Recommendations on Harmonized Europe-Wide Technical Requirements for Inland Navigation Vessels

Resolution No. 61

Amendment 4

Resolution No. 104

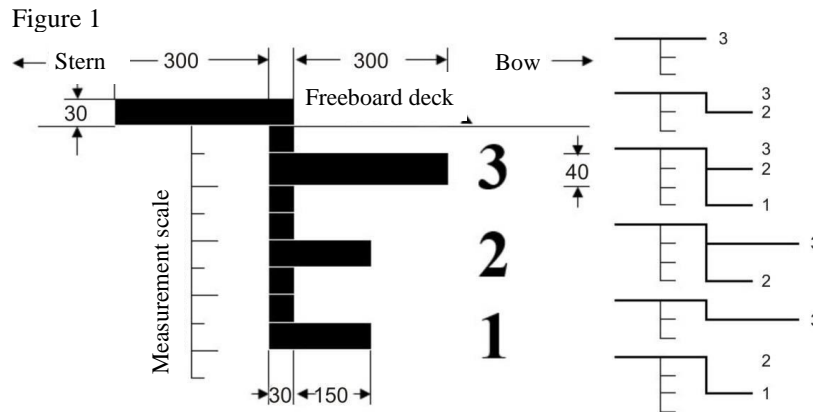
4-3.3 Draught marks are to be designed as follows:

(a) The topmost draught mark points towards the stern and is a rectangle 300 mm long and 30 mm high, the baseline of which is horizontal and coincides with the plane of the maximum authorized draught. If the topmost draught mark is the one applicable to zone 3, it is 40 mm high.

(b) The additional draught marks to be added point towards the bow and the following provisions apply:

(i) Draught marks for zone 3 comprise a rectangle 300 mm long and 40 mm high;

(ii) Draught marks for zones 1 and 2 comprise a rectangle 150 mm long and 30 mm high, the baseline of which is horizontal and coincides with the plane of the maximal authorized draught.

(c) If the draught mark to be added for zone 3 or 4 coincides with the uppermost draught mark, the latter can be dispensed with.

4-3.4 The number of the zone, in characters 60 mm high × 40 mm deep, is to be added next to the draught marks towards the bow; in the case of zone 4, the number can be dispensed with.

4-3.5 The draught marks according to paragraphs 4-3.3 and 4-3.4 and their orientation are to be in accordance with figure 1.

Figure 2

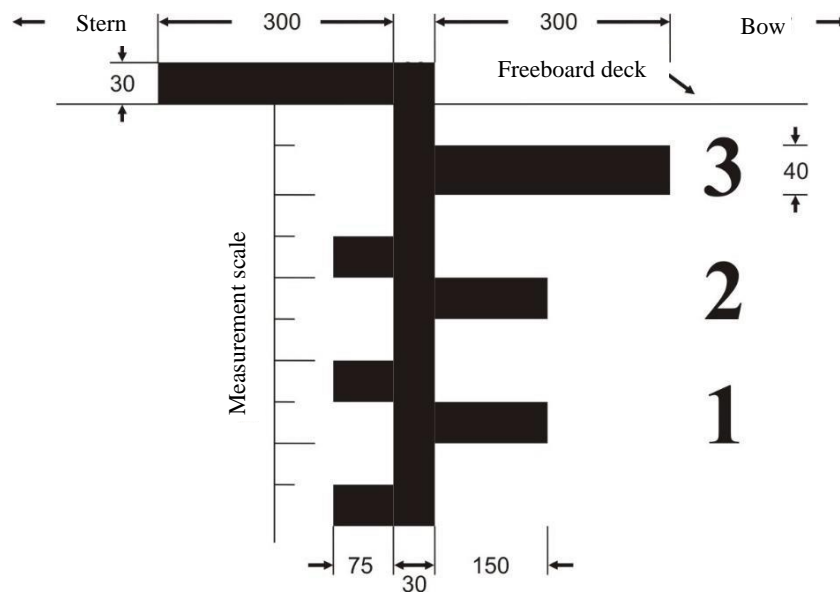
4-3.11 In the case of vessels with open holds, in addition to the provisions of paragraph 4-3.6 the draught marks for the relevant zones are to be supplemented by a rectangle 75 mm long by 30 mm high, pointing aft, the base of which is horizontal and coinciding with the level of the maximum permissible draught for navigation in the zone in question with open holds.

4-3.12 The draught marks according to paragraph 4-3.11 and their orientation are to be in accordance with figure 2.

Figure 3
Freeboard mark

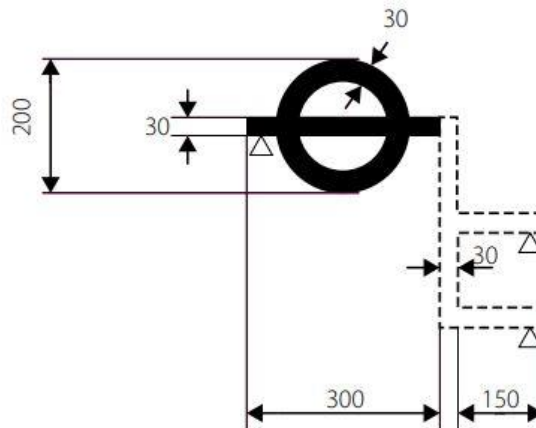
4-3A.4 The centrally located measurement/draught scale for zones 1 and 2 may be replaced by a freeboard mark.

The freeboard mark consists of a ring intersected through its centre by a horizontal line which shall be supplemented, if necessary, by additional freeboard lines.

The width of the ring and of all the other lines of the freeboard mark shall be 30 mm; the outer diameter of the ring shall be 200 mm; the length of the horizontal line intersecting the ring shall be 300 mm; and the size of the numerals designating the zones shall be 60 x 40 mm (see figure 3).

The centre of the ring shall be placed amidships. The lower edge of the horizontal line which intersects the ring shall pass through the centre of the ring and shall constitute the freeboard line.

If the vessel is intended to navigate in several navigation zones, a vertical line and additional freeboard lines 150 mm in length shall be applied forward of the centre of the ring.
